Meeting at 9:00 on 24 November 2016
Level 28 - Majestic Centre, 100 Willis St, Wellington

ACTIONS

The Active Modes Infrastructure Group agreed:

Pavement marking – 1000 x 1500 mm

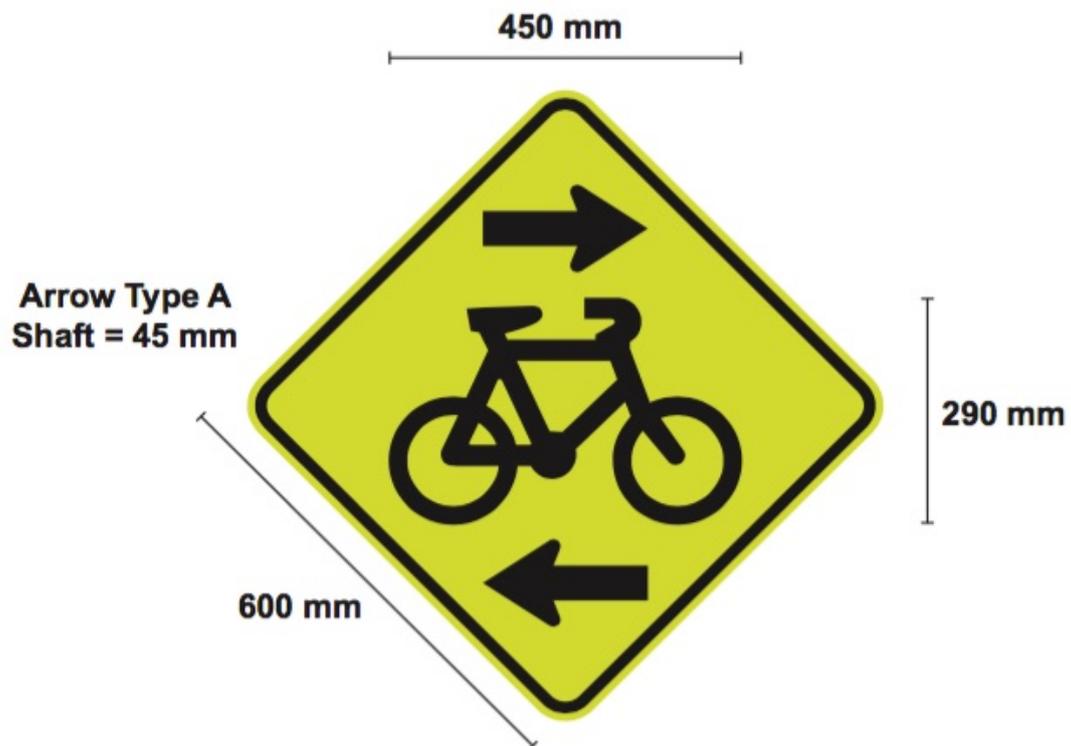
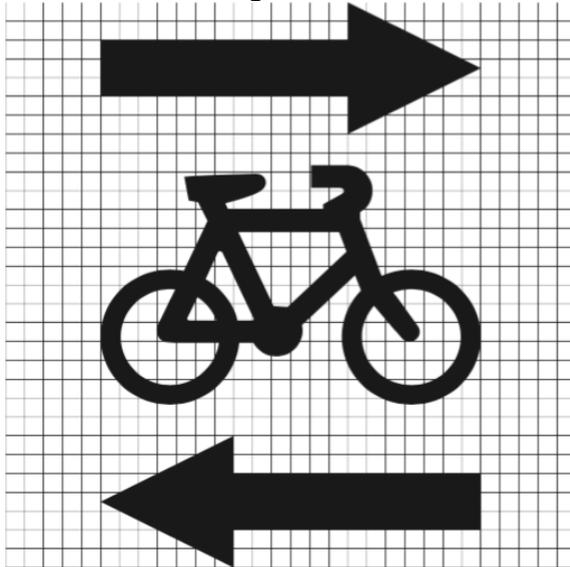
A. To approve the pavement marking and sign below for use at vehicle entrances crossing cycle paths:

(The scale of the arrows on the marking can be reduced to be closer to the proportions on the sign.)

(b)

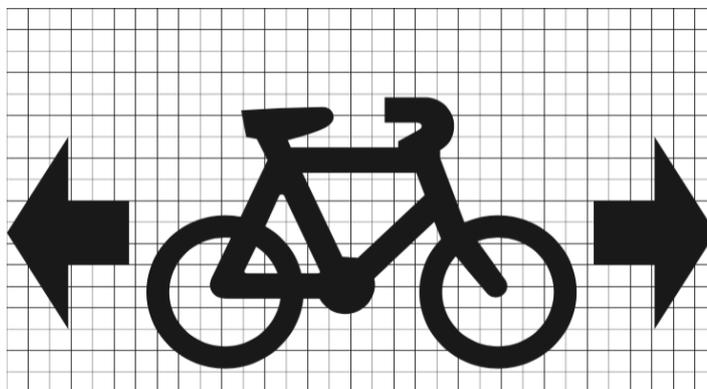
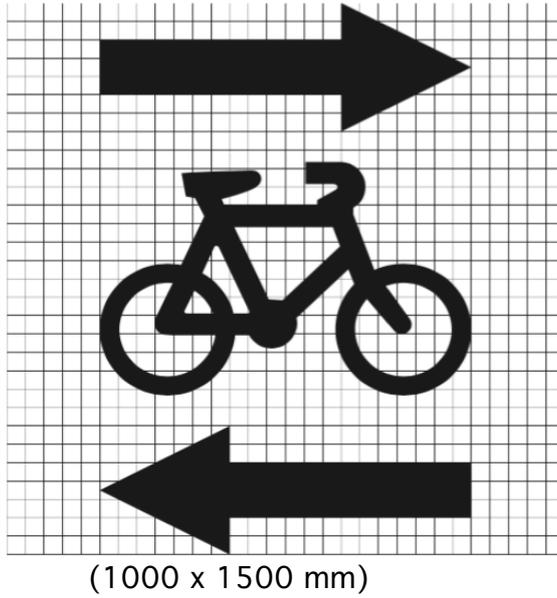
The pavement marking symbol was modified so that the wheels appear round. The reasons for this were:

- This marking will be used at driveways where the viewing distance is short and approach speed low, so that the elongated perspective of the standard road marking is not so important;
- The mock-up using the standard, elongated wheels, road marking symbol looked wrong;
- Using the standard, elongated road marking symbol takes up more space and the marking with the arrows above and below the cycle is about 2.5 metres tall. This makes the arrow on the top look a lot less significant than the arrow on the bottom, but it is the arrow on top that is arguably the most important.

The arrows are considered an important part of the marking, as they alert drivers to the fact that cyclists may be approaching from their left (when they might be inclined to look only for traffic coming from their right).

The principal concern is that this would create yet another cycle symbol template that could result in confusion for contractors and incorrect symbols being marked. It was also noted that whereas arrows above and below the symbol on the sign appear relatively small, because they fit into a lozenge shape, the arrows above and below the symbol in the pavement marking are large. This represents a lot of paint at every driveway.

Marking (a) has already been applied by AT and Christchurch City as being better suited to a single marking at a vehicle exit. NZTA and Wellington City have used marking (b) as being better able to be fitted into a 1 m wide stripe in a trial of a potential crossing marking undertaken on the Hutt Rd.

The meeting approved pavement marking (b) and sign (a) for use at vehicle entrances crossing cycle paths. The scale of the arrows on the marking can be reduced to be closer to the proportions on the sign:

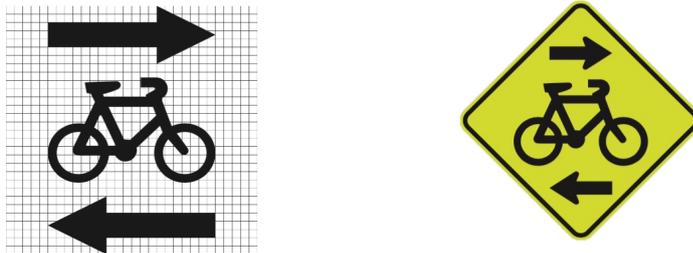
The previous meeting noted that the speed of entry is the critical consideration for cyclist crossings; a cyclist is able to enter a crossing too quickly for the average reaction time of motorists. Giving cyclists priority at crossings could exacerbate this risk and a distinctive marking that required both cyclists and motorists to slow down as they approached needed to be tested.

The current trial has looked at the effect of marking a series of 1 m wide stripes with 1 m separation across a wide vehicle exit. The trial has observed the effect of unclear priority on the behavior of motorists and cyclists. The preliminary finding is that the marking has made motorists more careful without making cyclists less careful:

- Before marking 32% of vehicles stopped before the cycleway
- After marking 68% of vehicles stopped before the cycleway.

The trial has shown, however, that the Emerald Green specification is too likely to darken and become dull and a brighter tone should be specified.

The meeting also agreed that the preferred colour specification for the green to be used on cycling facilities is Apple Green and the preferred red to be used on infrastructure for active modes is Signal Red.

Junction (4-way Stop) Cycle-priority Crossing TDC11.4(5)

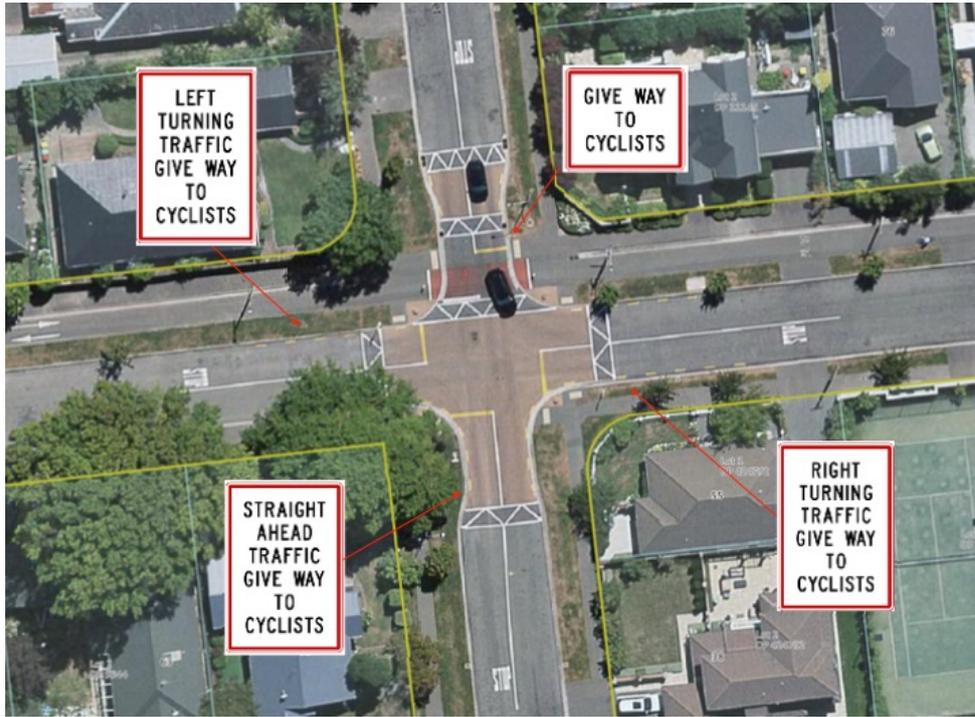
Five examples of Regulatory or Supplementary Signs for Give Way at cycle path intersections were circulated on 2 September. The supplementary 'TO CYCLISTS' has been installed on the Matai Street crossing in Christchurch City to inform motorists who they are giving way to. Prior to the installation of the supplementary sign there were numerous incidents of cyclists being cut off; following installation Christchurch City has not received a complaint.

The meeting agreed that the critical issue for the use of this supplementary is that it defines whom the motorist must give way to and could only, therefore, be used where no other traffic would cross.

The Matai Street West intersection with Harakeke Street is on the Christchurch Uni-Cycle major cycle route. The 4-way stop control has existed for years and so has the cycle path. To clarify to motorists that they are required to stop at the intersection and also give way to cyclists on the cycle priority crossing on the north side of the road, three of the Regulatory Supplementary signs indicated on the plan have been installed on separate poles near the Stop signs. The “Give Way to Cyclists” sign was not installed, as it would be confusing beside a Stop sign.

The meeting agreed that separate signage approved for intersections where motorists are required to also give way to cyclists on a cycle priority crossing at an intersection should be regulatory, rather than advisory.

After some discussion of preferences for using “cyclists”, “cycles” or just the cycle symbol, it was agreed that variations using the three options, as well as “pedestrians” or the pedestrian symbol, should be mocked up and tested in the simulator.

- **Regulatory supplementary sign:** 'TO CYCLISTS' for use with the TCD 11.4(5) cycle crossing; and
- **Regulatory Signage:** 'LEFT TURNING, RIGHT TURNING or STRAIGHT AHEAD TRAFFIC GIVE WAY TO CYCLISTS.
